# Product Change Notification

<b>Date Issued :</b>	September 15, 2023	<b>PCN Number :</b>	514148
<b>Reason for Change :</b>	Change to Product		
<b>Description of Change :</b>	This notification is to inform you about changes that are being made to drawings of the part(s) as identified in the list. This change will not affect the Fit, Form, Function, or appearance of the parts. And it may not result in a change to the specification or raw material.		
<b>Assessment of Change :</b>	No change to parts - Form/Fit/Function		
<b>Planned Implementation Date :</b>	March 15, 2024		
<b>Sample Availability Date:</b>	September 20, 2023		
<b>Internal Molex Qualification Date :</b>	September 29, 2023		
<b>Last date to request Samples by Customer :</b>	October 02, 2023		
<b>Traceability Code Markings / Date :</b>	No special marking on the product or packaging

Before Picture

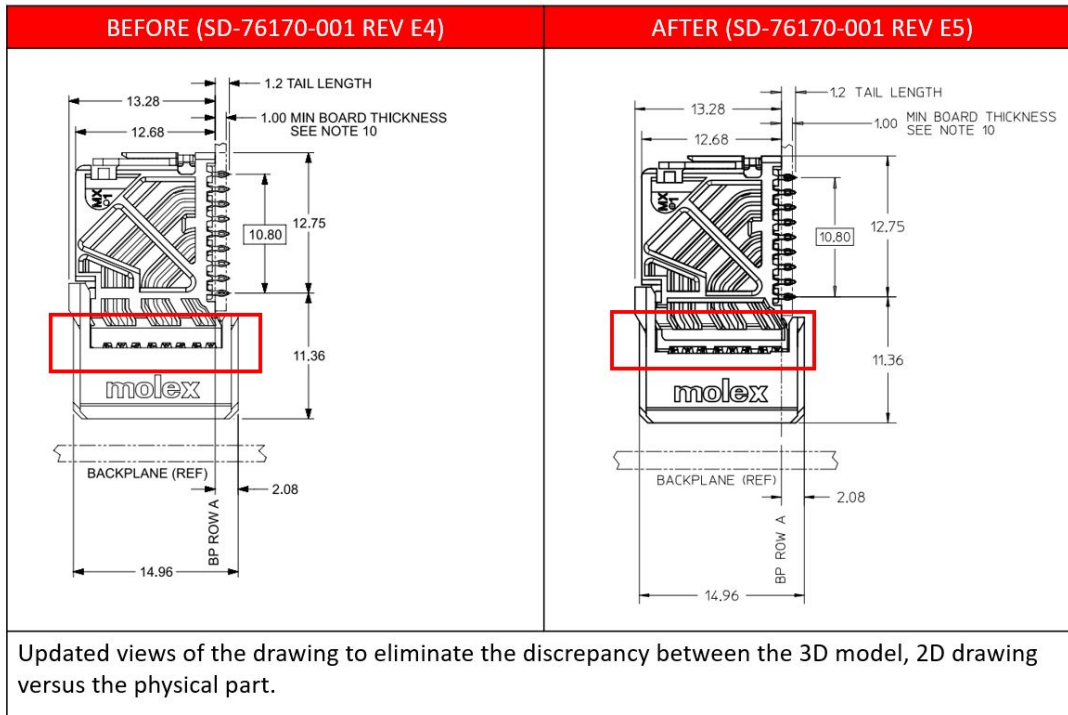
- This PCN was raised to rectify the document error which mainly was the discrepancy found between the 3D model, 2D drawing versus the physical part. The changes shall be made only on the drawing and model documents to reflect current physical parts.
- Product Impact
  - no impact to fit, form or function
- Part Number Impact
  - 76170-1006, 76170-1008, 76170-1010, 76170-1016
  - 76170-1036, 76170-1038, 76170-1020, 76170-1026
- No Qualification reports conducted as the changes doesn't impact product/physical part.
